AGENDA

**PLANNING & ZONING COMMISSION REGULAR MEETING
FRIDAY, SEPTEMBER 20, 2024 - 10:00 AM
MCALLEN DEVELOPMENT CENTER, 311 N. 15TH STREET
EXECUTIVE CONFERENCE ROOM 3**

KMB SUBDIVISION

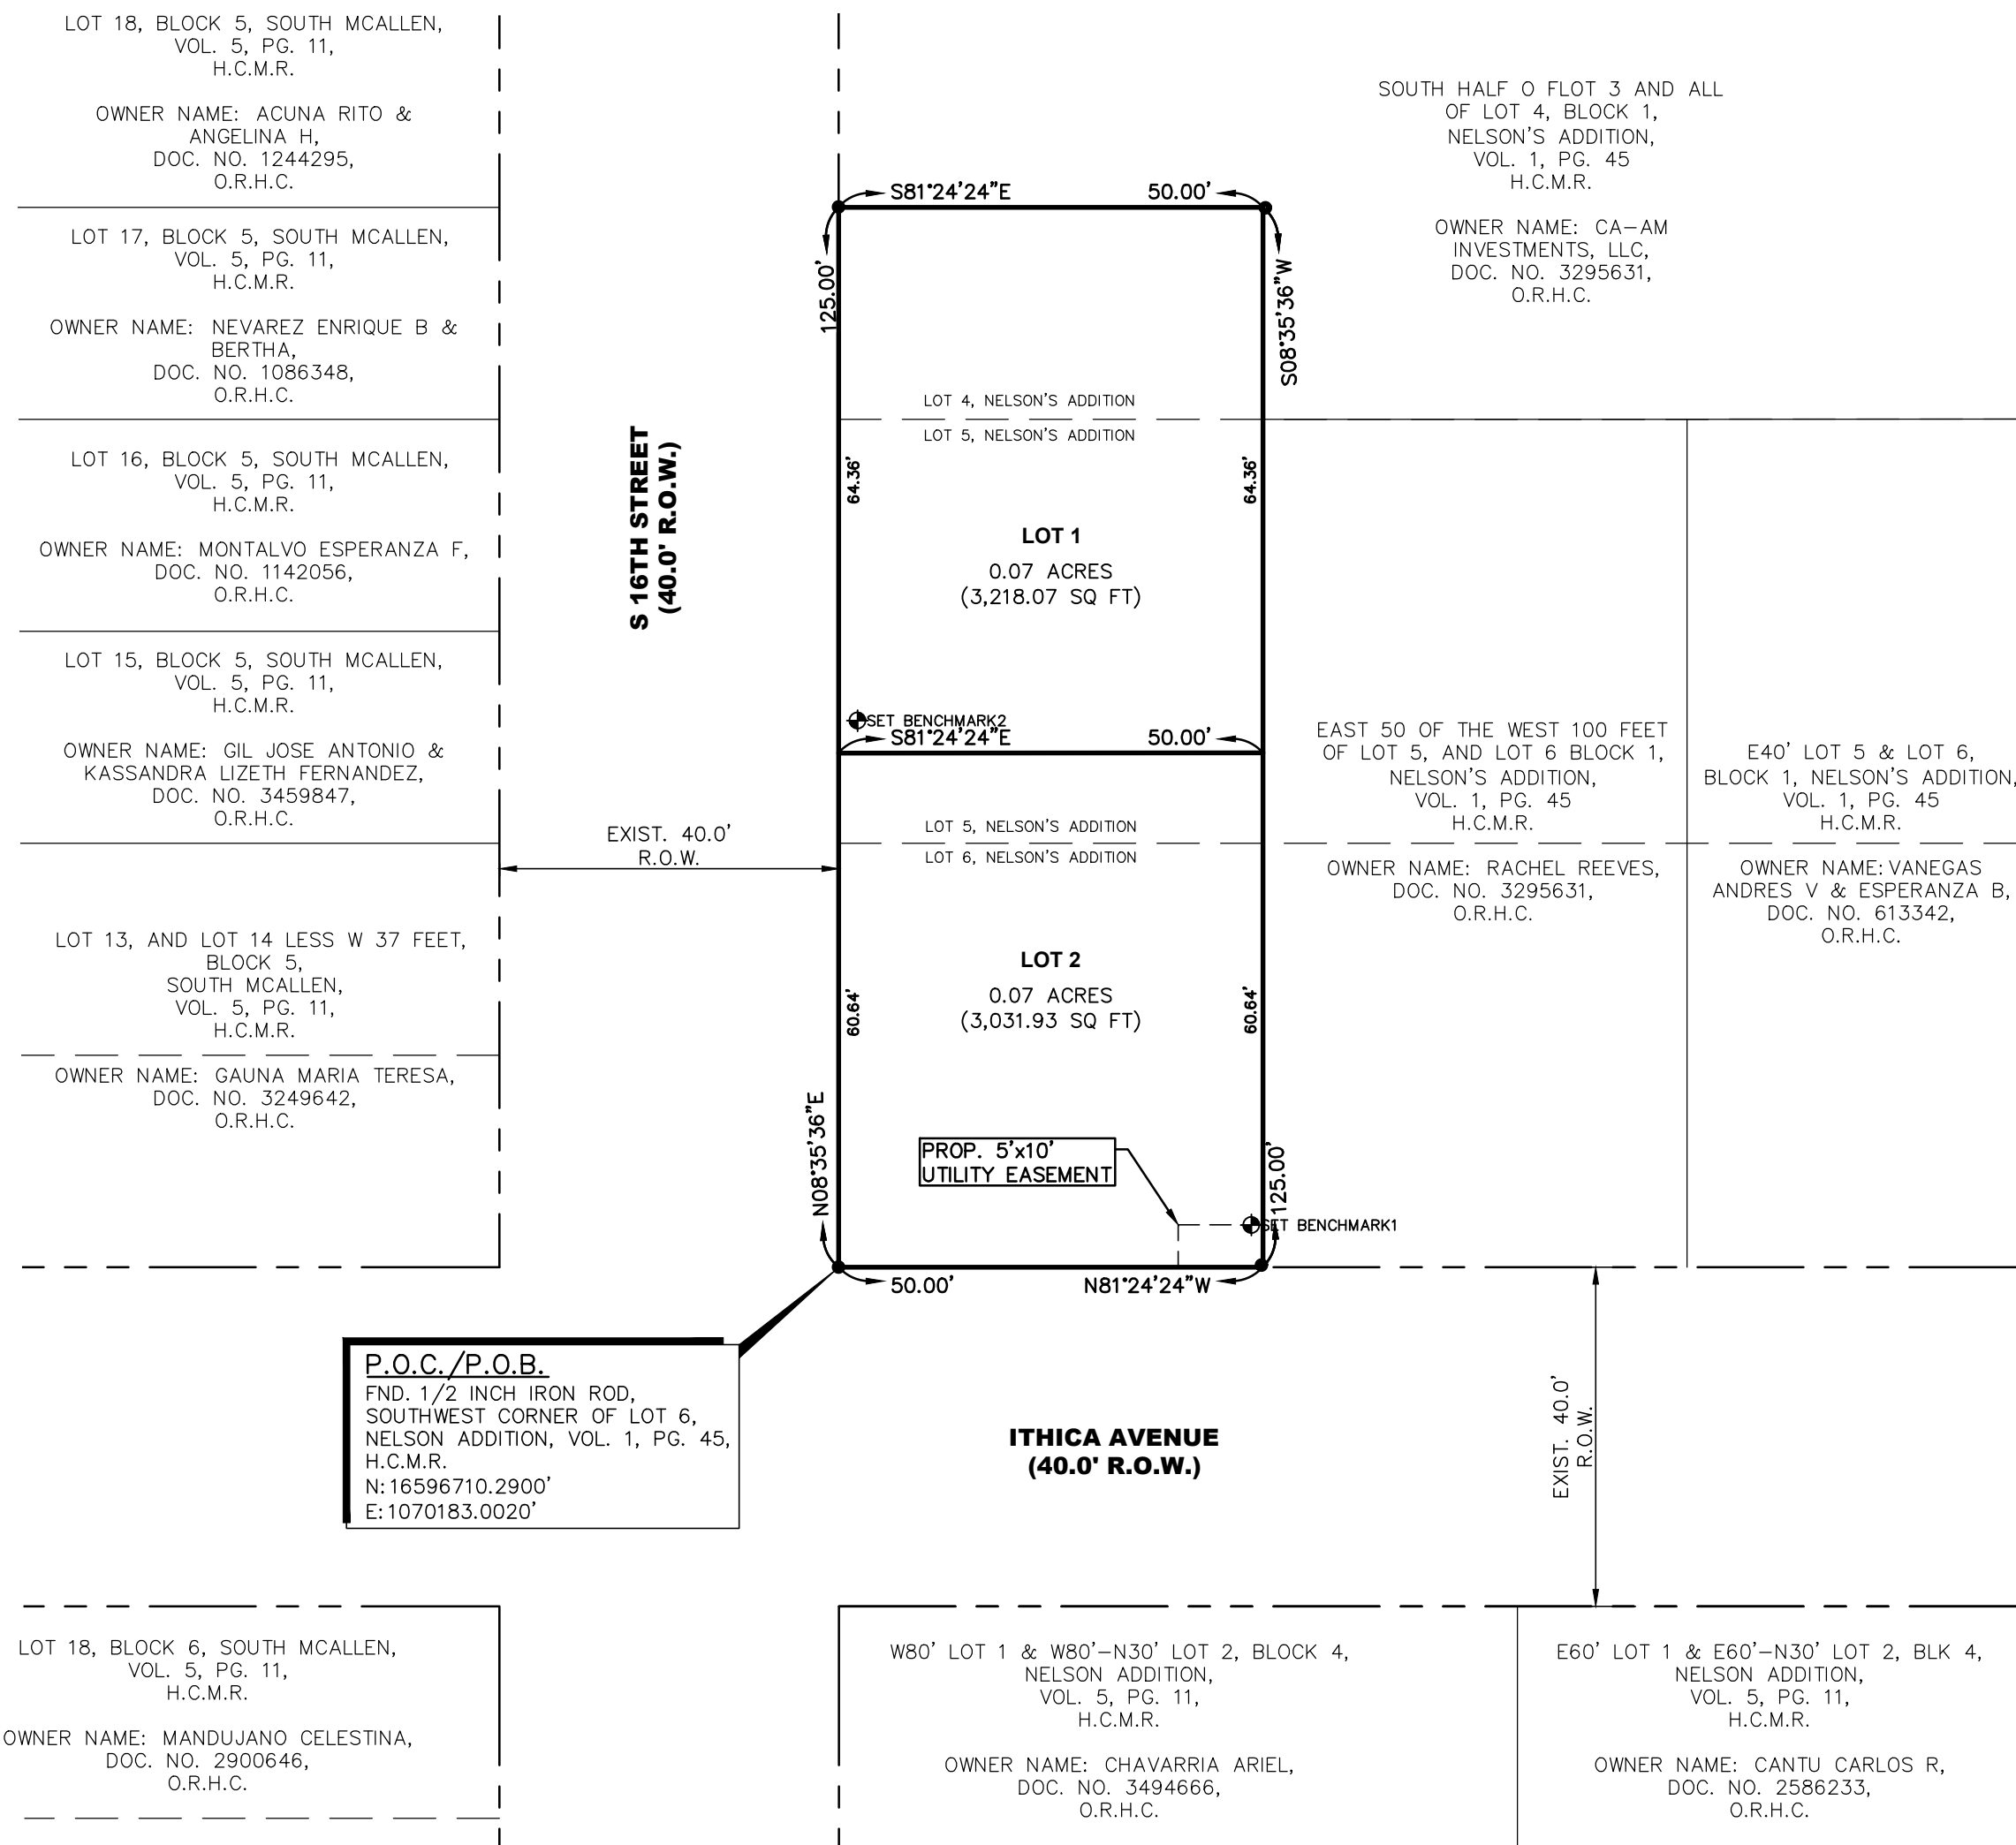
<p>Ithica Avenue: 10 ft. ROW dedication as required for 30 ft. from centerline for a 60 ft. total ROW. Paving: 40 ft. Curb & gutter: both sides - Label total ROW after accounting for dedication, prior to final. - Reference document number on the plat for the existing ROW and provide a copy for staff review as applicable, prior to final. - Engineer submitted a variance application (VAR2024-0038) to not dedicate additional ROW and maintain the existing 40 ft. ROW on August 9, 2024. If the request is approved staff recommends a 10-foot sidewalk and utility easement to be dedicated by plat as per the Engineering Department. **Subdivision Ordinance: Section 134-105 **Monies must be escrowed if improvements are required prior to final **COM Thoroughfare Plan</p>	<p>Non-compliance</p>
<p>South 16th Street: 10 ft. ROW dedication as required for 30 ft. from centerline for a 60 ft. total ROW. Paving: 40 ft. Curb & gutter: both sides - Label total ROW after accounting for dedication, prior to final. - Reference document number on the plat for the existing ROW and provide a copy for staff review as applicable, prior to final. - Engineer submitted a variance application (VAR2024-0038) to not dedicate additional ROW and maintain the existing 40 ft. ROW on August 9, 2024. If the request is approved staff recommends a 10-foot sidewalk and utility easement to be dedicated by plat as per the Engineering Department. **Subdivision Ordinance: Section 134-105 **Monies must be escrowed if improvements are required prior to final **COM Thoroughfare Plan</p>	<p>Non-compliance</p>

SETBACKS	
<p>* Front: (South 16th Street) Lot 1: In accordance with the Zoning Ordinance or in line with average setbacks of existing structures or greater for easements, whichever is greater applies. (Ithica Avenue) Lot 2: In accordance with the Zoning Ordinance or in line with average setbacks of existing structures or greater for easements, whichever is greater applies. - Revise front setback as shown above, prior to final. **Zoning Ordinance: Section 138-356 & 367</p>	Non-compliance
<p>* Rear: In accordance with Zoning Ordinance or greater for easements. - Revise plat note as shown above, prior to final. **Zoning Ordinance: Section 138-356</p>	Non-compliance
<p>* Sides: In accordance with the Zoning Ordinance or greater for easements - Revise plat note as shown above, prior to final. **Zoning Ordinance: Section 138-356</p>	Non-compliance
<p>* Corner: In accordance with Zoning Ordinance or greater for easements. - Revise plat note as shown above, prior to final. **Zoning Ordinance: Section 138-356</p>	Non-compliance

<p>* Garage: 18 ft. except where greater setback is required, greater setback applies. - Include a plat note as shown above, prior to final. **Zoning Ordinance: Section 138-356</p>	Non-compliance
<p>*ALL SETBACKS ARE SUBJECT TO INCREASE FOR EASEMENTS OR APPROVED SITE PLAN</p>	Applied
SIDEWALKS	
<p>* 4 ft. wide minimum sidewalk required on Ithica Avenue and South 16th Street **Subdivision Ordinance: Section 134-120</p>	Applied
<p>* Perimeter sidewalks must be built or money escrowed if not built at this time.</p>	Required
BUFFERS	
<p>* 6 ft. opaque buffer required from adjacent/between multi-family residential and commercial, and industrial zones/uses. - Revise plat note as shown above, prior to final. **Landscaping Ordinance: Section 110-46</p>	Non-compliance
<p>* 8 ft. masonry wall required between single family residential and commercial, industrial, or multi-family residential zones/uses. **Landscaping Ordinance: Section 110-46</p>	Applied

<p>* As per Traffic Department, Trip Generation required to determine if TIA is required, prior to final plat. - As per Traffic Department, Trip Generation is waived for 2 lot townhouse subdivision.</p>	<p>Applied</p>
<p>* Traffic Impact Analysis (TIA) required prior to final plat.</p>	<p>NA</p>
<p>COMMENTS</p>	
<p>Comments: - Owner's signature block must comply with requirements set forth in Section 134-61. - Clarify if utility easement will be dedicated by plat or separate document. - Any abandonments must be done by separate document, not by plat. - Subdivision needs to be renamed to "Nelson Addition Lots 5A and 6A Subdivision", prior to final. Application will need to be revised to reflect the name change as well. *Must comply with City's Access Management Policy.</p>	<p>Applied</p>

RECOMMENDATION	
Recommendation: STAFF RECOMMENDS APPROVAL OF THE SUBDIVISION IN REVISED PRELIMINARY FORM, SUBJECT TO THE CONDITIONS NOTED, DRAINAGE, UTILITY APPROVAL AND DISAPPROVAL OF THE REQUESTED VARIANCE.	Applied

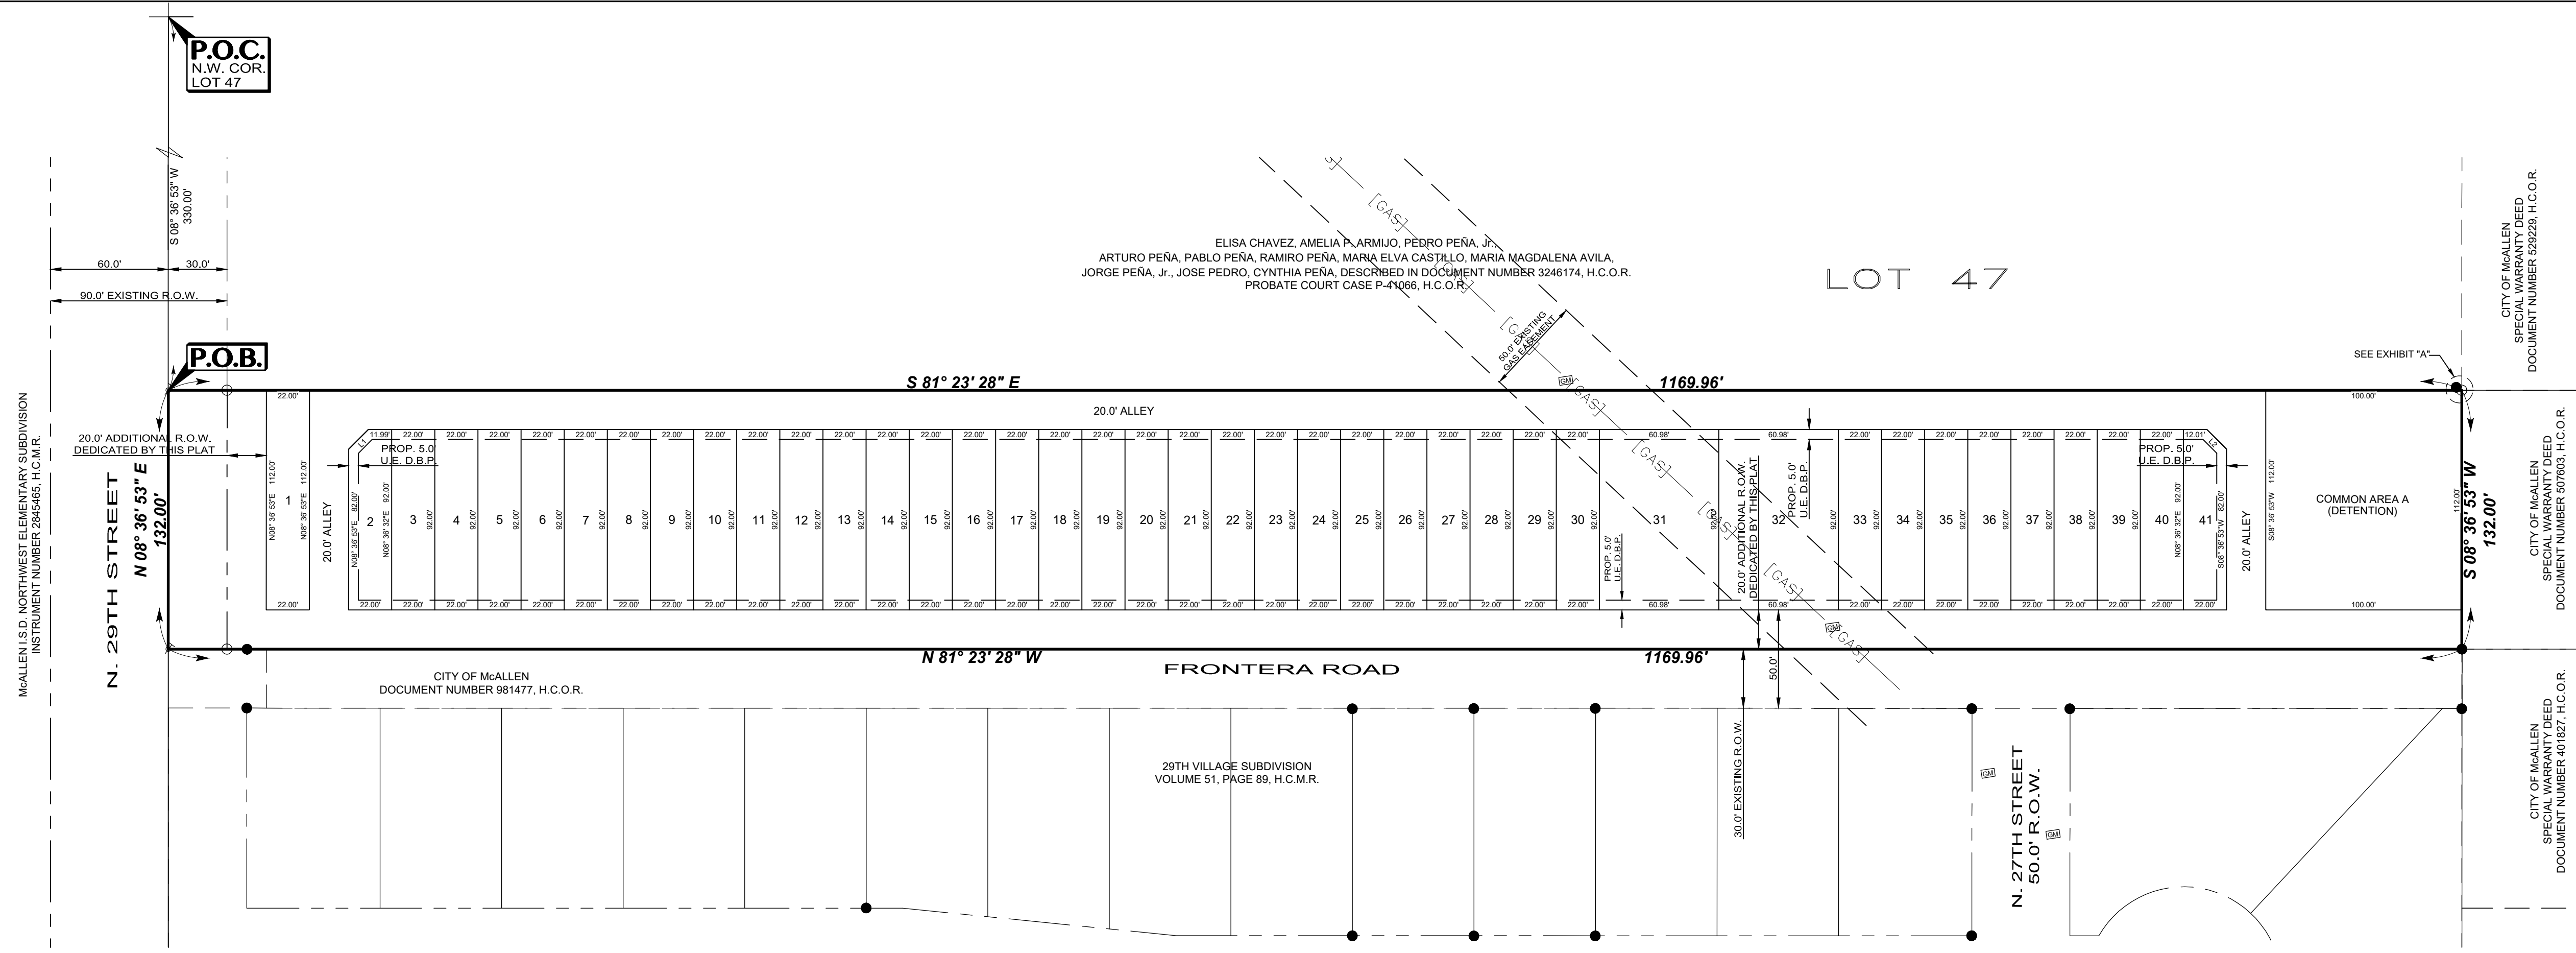
SUBDIVISION NAME: 29TH SUBDIVISION	
REQUIREMENTS	
STREETS AND RIGHT-OF-WAYS	
<p>North 29th Street: Dedication as needed for 50 ft. from centerline for 100 ft. total ROW Paving : 65 ft. Curb & gutter: Both Sides - Label centerline to establish ROW requirements. - Provide document numbers on plat regarding any existing dedication or acquisitions as applicable prior to final as well as documents for staff review. Dedication requirements to be established once ROW details regarding existing dedications are provided, finalize prior to final. - Label ROW after accounting for dedication as Total ROW, prior to final. - Label ROW from centerline to new plat boundary, prior to final. **Subdivision Ordinance: Section 134-105 **Monies must be escrowed if improvements are required prior to recording. **COM Thoroughfare Plan</p>	Non-compliance
<p>Frontera Road: Minimum 30 ft. ROW dedication for 60 ft. total ROW Paving: 40 ft. Curb & gutter: both sides - Label the centerline to establish ROW requirements. - Label ROW after accounting for dedication as total ROW, prior to final. - Provide document numbers on plat regarding any existing dedication or acquisitions as applicable prior to final as well as documents for staff review. Dedication requirements to be established once ROW details regarding existing dedications are provided, finalize prior to final. **Subdivision Ordinance: Section 134-105 **Monies must be escrowed if improvements are required prior to final **COM Thoroughfare Plan</p>	Non-compliance

<p>North 27th Street: 50 ft. ROW Paving: 32 ft. Curb & gutter: both sides - Provide for North 27th Street to provide connectivity to the N/S **Subdivision Ordinance: Section 134-105 **Monies must be escrowed if improvements are required prior to final **COM Thoroughfare Plan</p>	Non-compliance
<p>Paving _____ Curb & gutter _____ **Subdivision Ordinance: Section 134-105 **Monies must be escrowed if improvements are required prior to final **COM Thoroughfare Plan</p>	Applied
<p>Paving _____ Curb & gutter _____ **Subdivision Ordinance: Section 134-105 **Monies must be escrowed if improvements are required prior to final **COM Thoroughfare Plan</p>	Applied
<p>* 1,200 ft. Block Length - If rezoning to R-3T is not approved R-1 zoning requirements will apply. **Subdivision Ordinance: Section 134-118</p>	Non-compliance

<p>* 900 ft. Block Length for R-3 Zone Districts - Subdivision layout does not comply with block length requirement, please revise accordingly prior to final. If no changes, submit a variance request for 900 ft. maximum block length requirement. - If rezoning to R-3T is not approved R-1 zoning requirements will apply. **Subdivision Ordinance: Section 134-118</p> <p>* 600 ft. Maximum Cul-de-Sac **Subdivision Ordinance: Section 134-105</p>	<p>Non-compliance</p>
<p>ALLEYS</p>	<p>NA</p>
<p>ROW: 20 ft. Paving: 16 ft. - Must provide for 8 x 8 ft dumpster easements and comply with Public Works requirements. *Alley/service drive easement required for commercial/multi-family properties **Subdivision Ordinance: Section 134-106</p>	<p>Non-compliance</p>
<p>SETBACKS</p>	
<p>* Front: 10 ft. or greater for easements - Revise front setback as shown above, prior to final. - If rezoning to R-3T is not approved R-1 zoning requirements will apply. **Zoning Ordinance: Section 138-356</p>	<p>Non-compliance</p>

<p>* Rear: In accordance with the Zoning Ordinance or easements, whichever is greater applies - Clarify rear setback, prior to final. - If rezoning to R-3T is not approved R-1 zoning requirements will apply. **Zoning Ordinance: Section 138-356</p>	<p>Non-compliance</p>
<p>* Sides: In accordance with the Zoning Ordinance or greater for easements - If rezoning to R-3T is not approved R-1 zoning requirements will apply. **Zoning Ordinance: Section 138-356</p>	<p>Non-compliance</p>
<p>* Corner: 10 feet or greater for easements - Revise corner setback as shown above, prior to final. **Zoning Ordinance: Section 138-356</p>	<p>Non-compliance</p>
<p>* Garage: 18 feet except where greater setback is required; greater setback applies - Revise garage setback as shown above, prior to final. **Zoning Ordinance: Section 138-356</p>	<p>Non-compliance</p>
<p>*ALL SETBACKS ARE SUBJECT TO INCREASE FOR EASEMENTS OR APPROVED SITE PLAN</p>	<p>Applied</p>

<p>* 8 ft. masonry wall required between single family residential and commercial, industrial, or multi-family residential zones/uses **Landscaping Ordinance: Section 110-46 *Perimeter buffers must be built at time of Subdivision Improvements.</p>	Applied
NOTES	Required
<p>* No curb cut, access, or lot frontage permitted along North 29th Street and Frontera Road - Provide a plat note as shown above, prior to final. **Must comply with City Access Management Policy * Site plan must be approved by the Planning and Development Departments prior to building permit issuance. - Any owner, builder or developer of a multiple-family, condominium or townhouse dwelling complex of five units or more on a single lot or parcel, or five single-family attached units, shall submit to the planning department for review a site and building plan for the proposed development. **Zoning Ordinance: Section 138-210 * Common Areas, detention areas etc. must be maintained by the lot owners and not the City of McAllen. - Revise plat note #10 as shown above, prior to final. * Common Areas for commercial developments provide for common parking, access, setbacks, landscaping, etc. * Developer/Homeowner's Association/Owner, their successors and assignees, and not the City of McAllen shall be responsible for compliance of installation and maintenance and other requirements per Section 134-168 of the Subdivision Ordinance, including but not limited to common areas and its private streets. **Section 110-72 applies if public subdivision is proposed. **Section 134-168 applies if private subdivision is proposed. **Landscaping Ordinance: Section 110-72 **Subdivision Ordinance: Section 134-168 * Homeowner's Association Covenants must be recorded and submitted with document number on the plat, prior to recording. **Section 110-72 applies if public subdivision is proposed. **Section 134-168 applies if private subdivision is proposed. **Landscaping Ordinance: Section 110-72 **Subdivision Ordinance: Section 134-168</p>	Non-compliance

Applied
	Non-compliance
	NA
	Required
	Required
LOT REQUIREMENTS	
<p>* Lots fronting public streets - Once plat is revised to show North 27th Street, detention area must be a minimum 25 ft. width and front an interior street. **Subdivision Ordinance: Section 134-1</p>	Non-compliance
<p>* Minimum lot width and lot area - As per plat submitted on August 29, 2024, Lots 2 and 41 are not meeting the minimum 2,000 sq. ft. lot area, please revise accordingly. - Once plat is revised to show North 27th Street, detention area must be a minimum 25 ft. width and front an interior street . Lots 1 & 41 will not have enough width for a buildable area after accounting for corner setback. *Corner lots should be at least four feet wider than the minimum lot size in residential zones. **Provide preliminary site plan for multi-family lots to verify compliance with landscaping requirements. **Zoning Ordinance: Section 138-356</p>	Non-compliance
